HISTORIC AND DESIGN REVIEW COMMISSION

HDRC CASE NO: 2023-322
ADDRESS: 506 STIEREN
LEGAL DESCRIPTION: NCB 2966 (STIEREN STREET REPLAT), BLOCK 1 LOT 18
ZONING: RM-4, H
CITY COUNCIL DIST.: 1
DISTRICT: King William Historic District
APPLICANT: IDOWU NTOKA/ION HOMES AND RESORT USA LLC
OWNER: IDOWU NTOKA/ION HOMES AND RESORT USA LLC
TYPE OF WORK: New construction of two, 2-story duplex structures
APPLICATION RECEIVED: October 03, 2023
60-DAY REVIEW: December 12, 2023
CASE MANAGER: Rachel Rettaliata

The applicant is requesting a Certificate of Appropriateness for approval to construct two, 2-story duplex structures on the lot addressed 506 Stieren.

1 FIRST BLDG FRONT ELEVATION
3/16" = 1'-0"

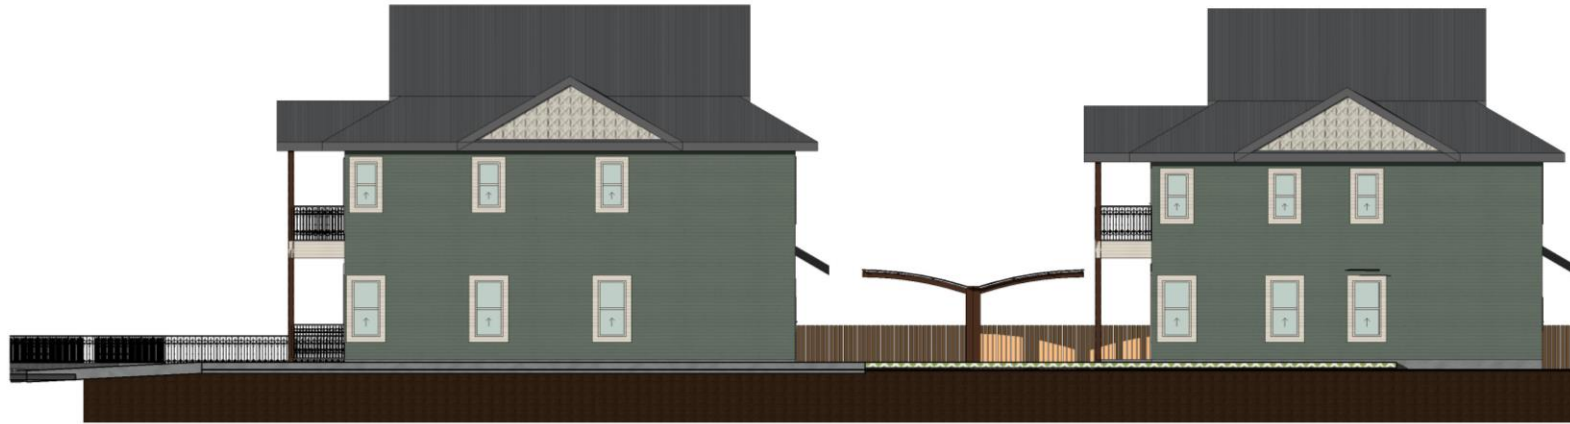
- f. **SCALE & MASSING** – The applicant has proposed to construct two, 2-story duplex structures. The structures will total 29'-7" in height. According to the Historic Design Guidelines, new construction should not exceed the height of the majority of existing structures by more than 1-story. The predominant surrounding residential context features 1-story residential and one 2-story commercial structure, which range in height from 14 feet to 32 feet. The average height of structures in the immediate context is approximately 21 feet. Guideline 8.A.ii for Medium-Density and Multifamily states that multiple dwelling units should be incorporated into historically common building sizes and forms within the established context area. For example, in context areas having larger buildings, four units may be appropriately combined into a single, two-story building form. In context areas with smaller buildings, a more appropriate response would be to separate the units into smaller, individual building forms. Additionally, Guideline 8.D.iii for Medium-Density and Multifamily states that applicants should separate building massing into distinguishable architectural bays consistent with historic buildings within the established context area. This is best accomplished through a change in wall plane or materials, or by aligning appropriately scaled fenestrations. Staff finds the proposal generally consistent with the Guidelines.

- h. **ROOF FORM** – The applicant has proposed to install a modified Dutch gable composition shingle roof featuring front gable detailing and front gable porch roofs on the front façade, with side gables. Guideline 8.D.i for Medium-Density and Multifamily states that projects should incorporate roof forms—pitch, overhangs, and orientation—that are consistent with those found in the established context area. Flat or shed roofs are not typical of primary structures in San Antonio's residential historic districts and should be avoided. Staff finds the proposal generally appropriate.

- i. **ENTRANCES & PORCHES** – The applicant has proposed two central double-height front porches as entrances on Unit 1, facing Stieren, and two flanking double-height porches as entrances on Unit 2, facing Stieren and oriented toward the rear elevation of Unit 1. Per the Guidelines for New Construction, the primary façade of new buildings should be in keeping with established patterns in terms of porches, entrances, orientation, and setbacks. Additionally, Guideline 8.D.ii for Medium-Density and Multifamily states that traditional front porch depths and forms should be utilized to establish a pedestrian scale along the street frontage. Porch designs should be similar in dimension and form as those found on historic buildings within the established context area. Staff generally finds the front setback and porch design to be consistent with the Guidelines.

- ii. That the applicant installs traditionally sized windows in lieu of the proposed slider windows on the rear elevations based on finding j. The applicant must submit updated elevation drawings to staff for review and approval prior to the issuance of a Certificate of Appropriateness.

1 RIGHT ELEVATION
3/16" = 1'-0"

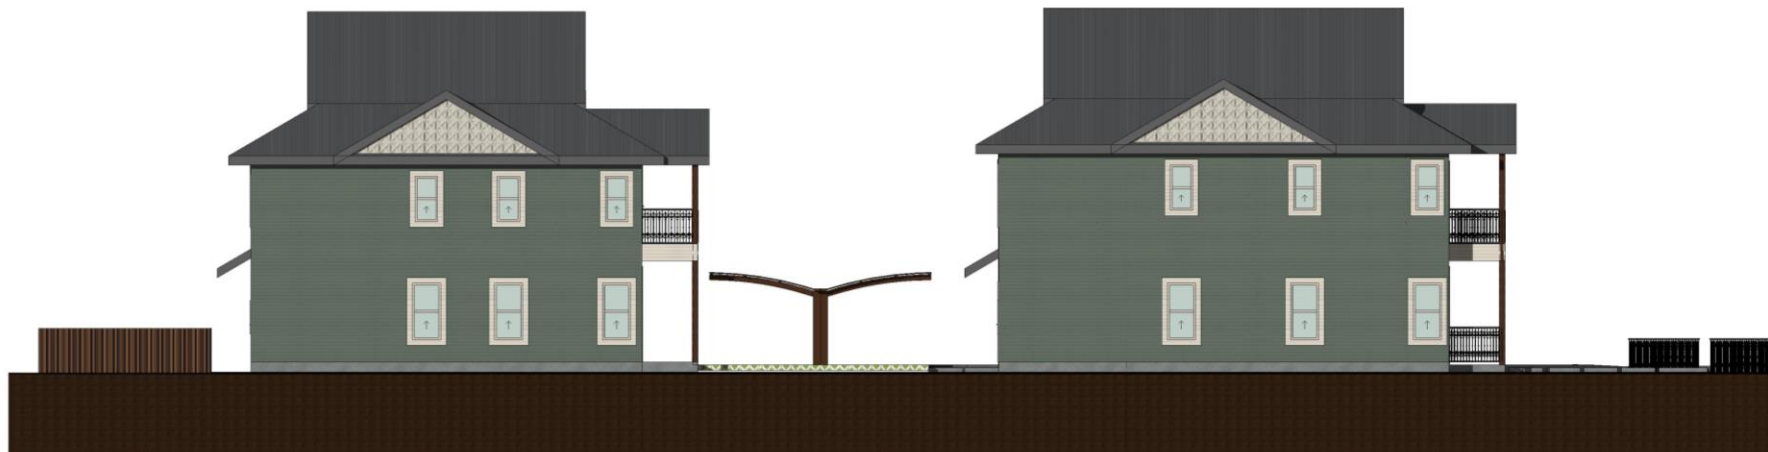
- l. **MATERIALS** – Based on the submitted elevations, the applicant has proposed materials that include composition shingle roofing, Hardie plank siding, Hardie shingle cladding, Pella Reserve wood windows, and

- v. That the applicant installs Hardie or composition siding that features a reveal no more than 6 inches and a smooth texture based on finding l.
